Agenda  
Village of Arlington Heights  
Design Commission  
Community Room, 3rd Floor

Arlington Heights Village Hall  
33 S. Arlington Heights Road  
Arlington Heights, IL 60005  
September 12, 2017  
6:30 PM

MINUTES OF  
THE VILLAGE OF ARLINGTON HEIGHTS  
DESIGN COMMISSION MEETING  
HELD AT THE ARLINGTON HEIGHTS MUNICIPAL BUILDING  
33 S. ARLINGTON HEIGHTS RD.  
AUGUST 22, 2017

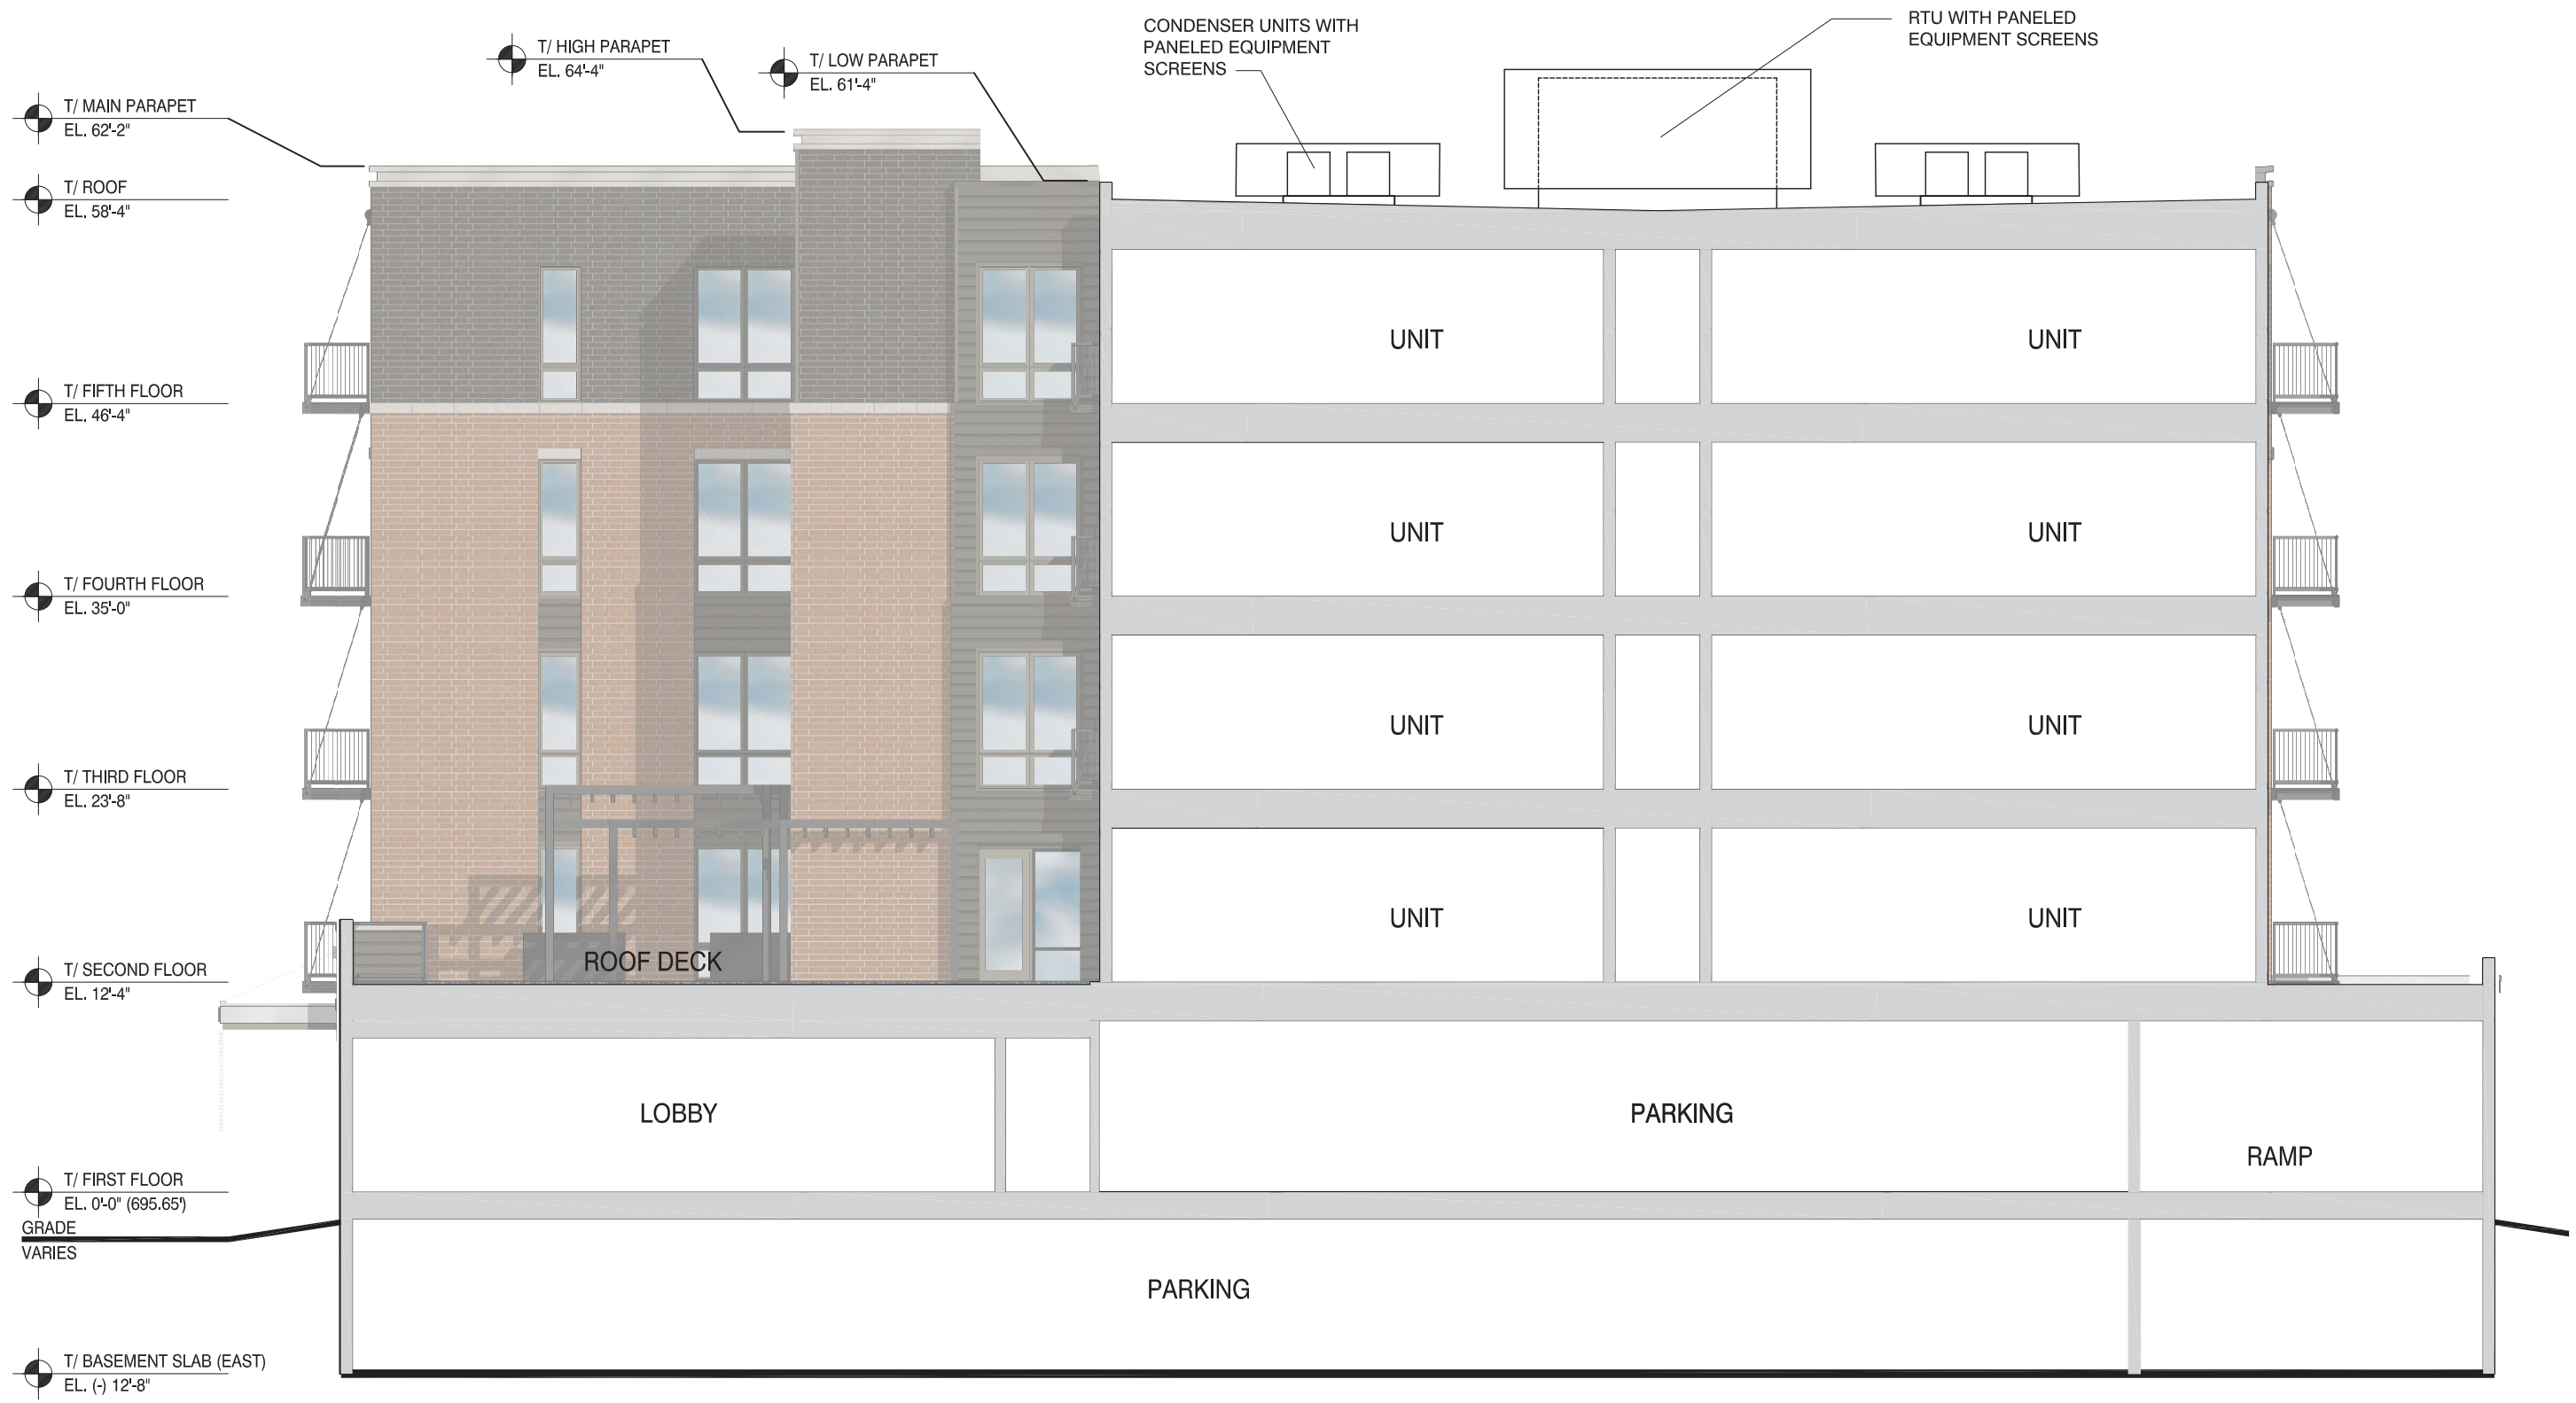
- o At least one additional false window should be added to the first floor east elevation to add interest and break up the brick wall.
- **Sign.** The font on the “Sigwalt Luxury Apartment” sign has been changed to a simpler more modern style, and it is positioned off-center on the wall for a more contemporary appearance.

1. Add at least one additional false window on the east elevation, first floor.
2. It is recommended that the Morton Sweetspire around the electrical transformer be changed to an evergreen shrub to provide year round screening.

NORTH ELEVATION

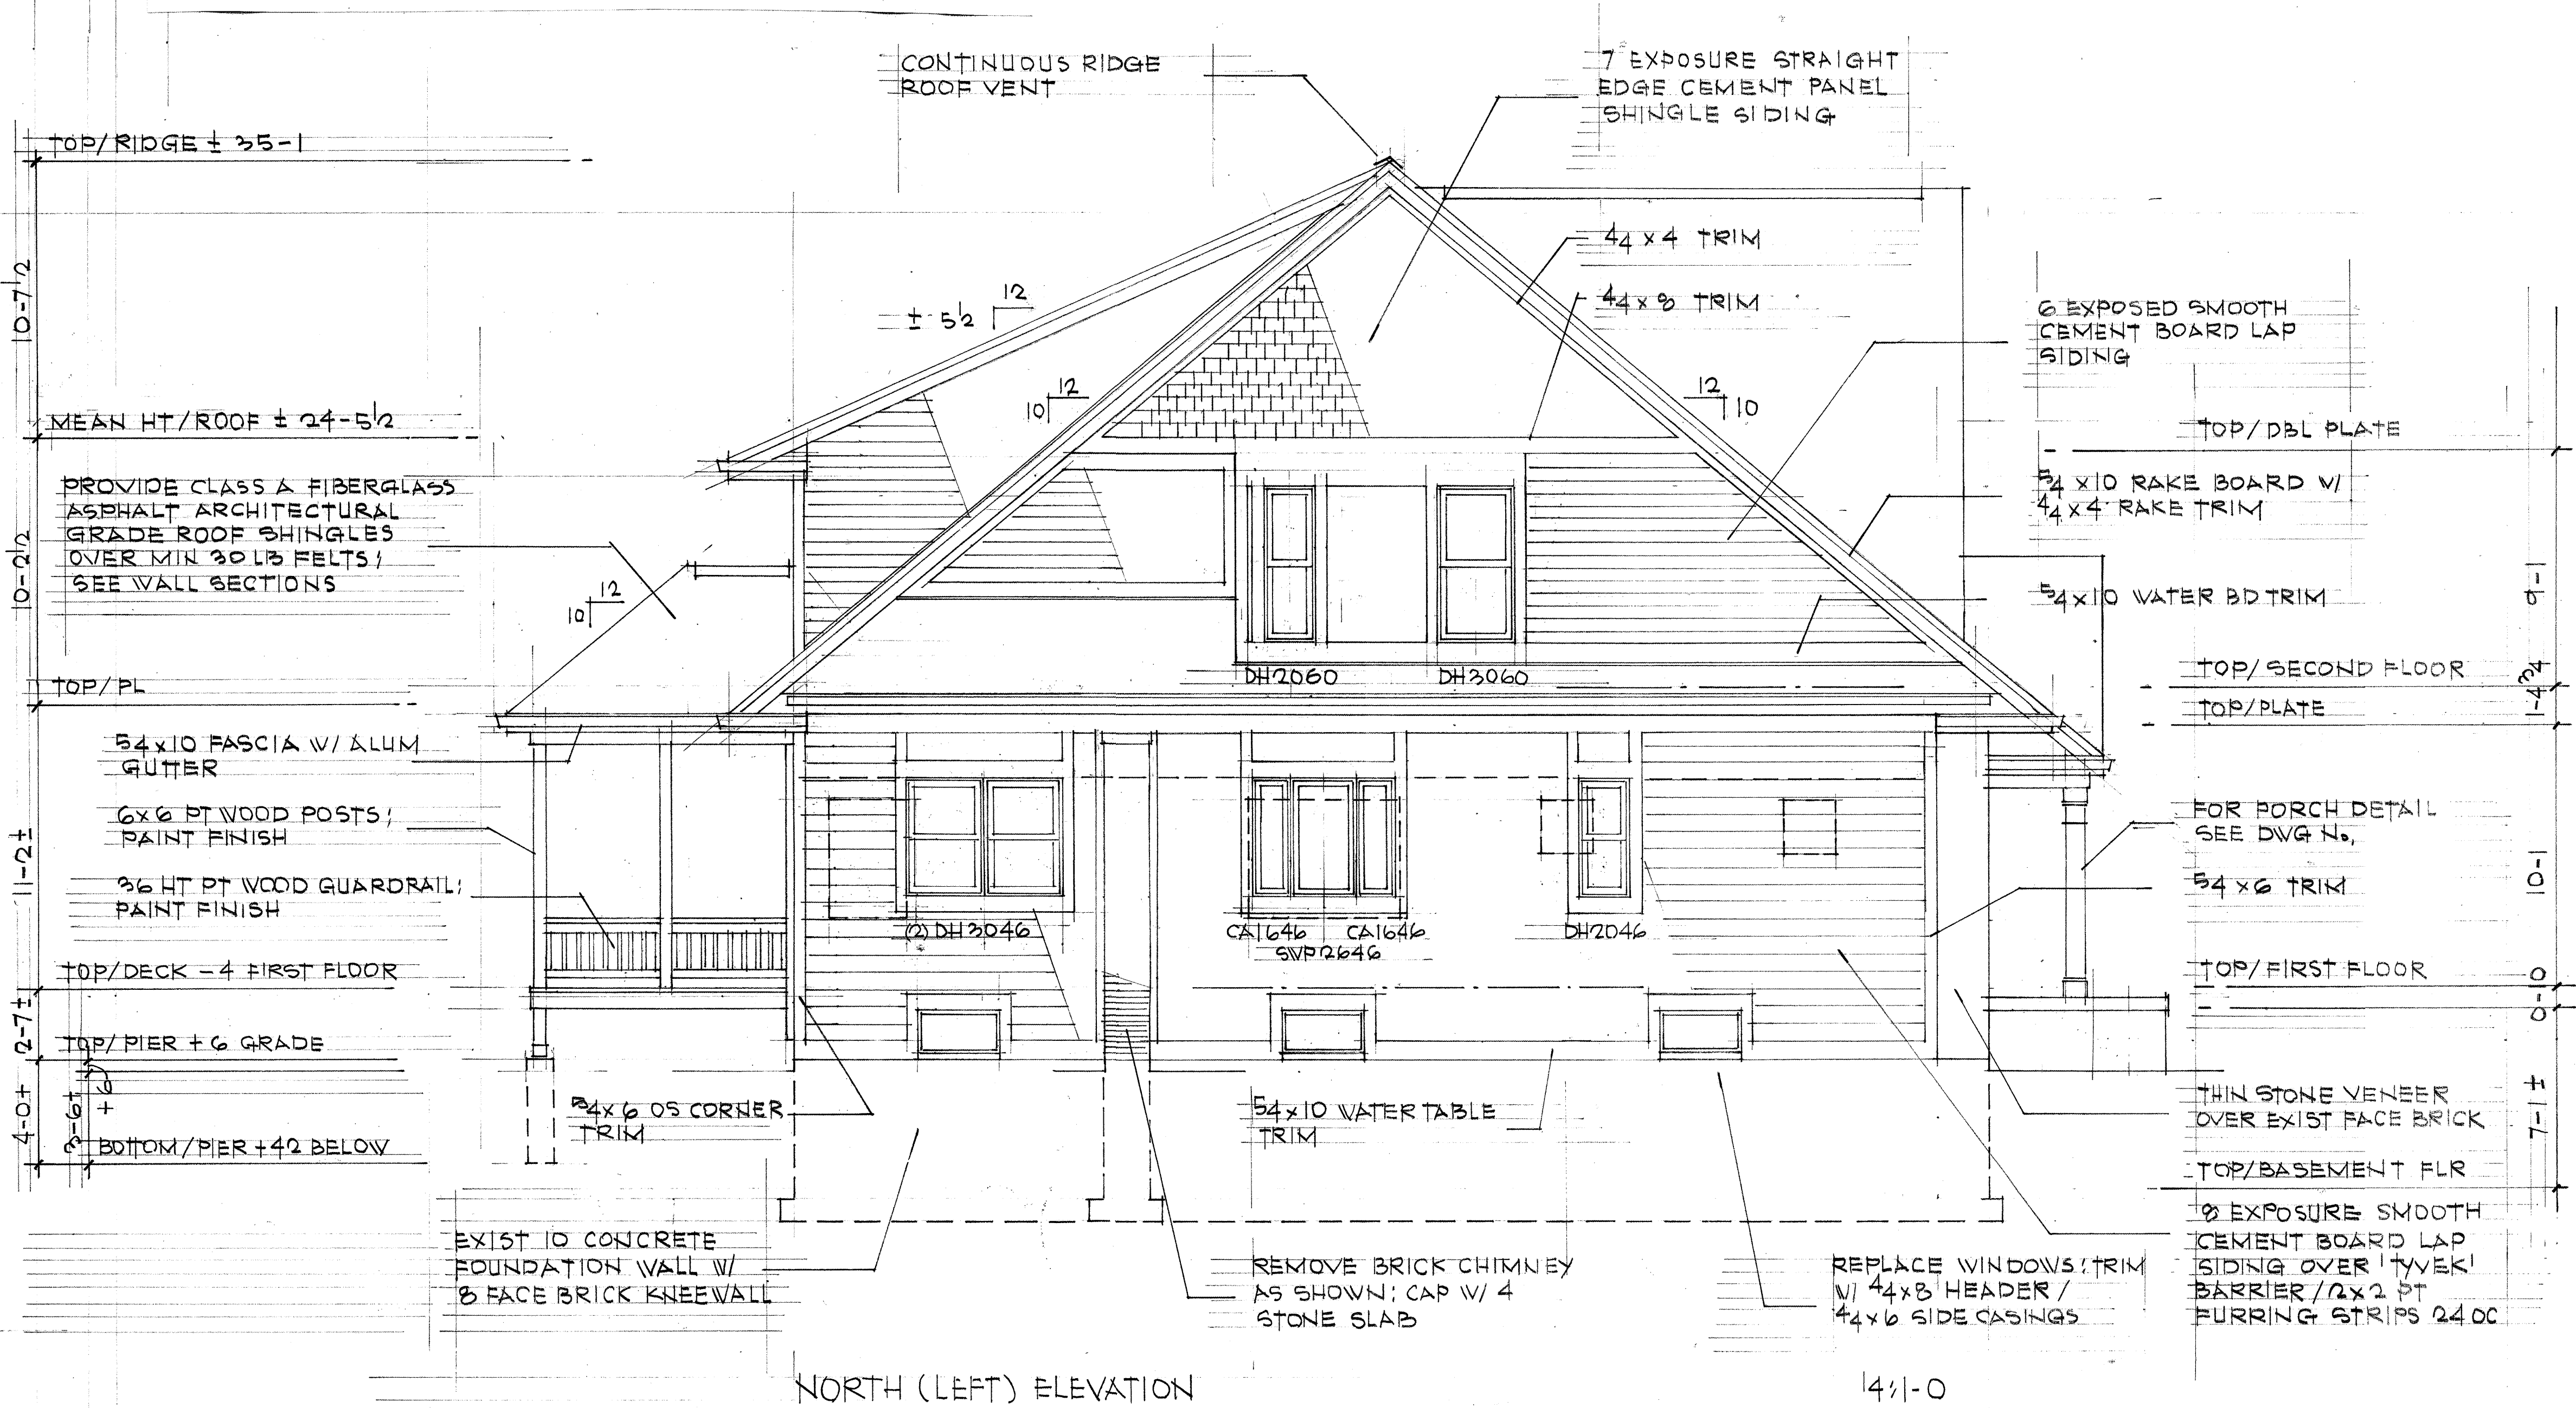
The right side elevation has a nice symmetrical composition, but there is only one window on the first floor. A second square window should be added to help break up the large blank wall.
